Questionnaire 1 (Clarification) Exemption 1 of RoHS Annex IV

Cadmium and lead in detectors for ionising radiation:

Figure 1: Principle of Operation

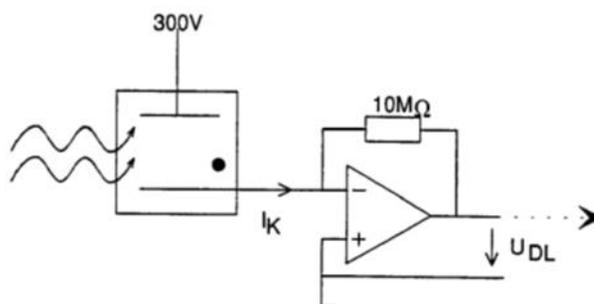
1. The operation of the ionization chamber is not clear. What is the link between the current generated (between the anode and cathode) and the capacitor that shuts down the X-ray tube? What is the role of lead?

Lead is used as the negative electrode of the ionization chamber. X-rays ionize the air inside the chamber which allows secondary electrons to be emitted from the negative lead coated electrode and travel to the positive electrode. This generates a current through the chamber and the associated circuit, which determines the quantity of ionisation in the chamber from the X-radiation exposure. A typical circuit is shown below:

The chamber operates according to the ionization principle. In an air capacitor, charged with +300V, a current (I_K) proportional to the dose rate of the X-ray radiation is produced. The sensitivity results from the characteristic design of the electrode. This small current in the pA to nA range is converted to a DC voltage (U_{DL}) in the mV to V range and fed via a shielded cable (JK1 and/or JK2A) to the main amplifier in the X-ray generator.
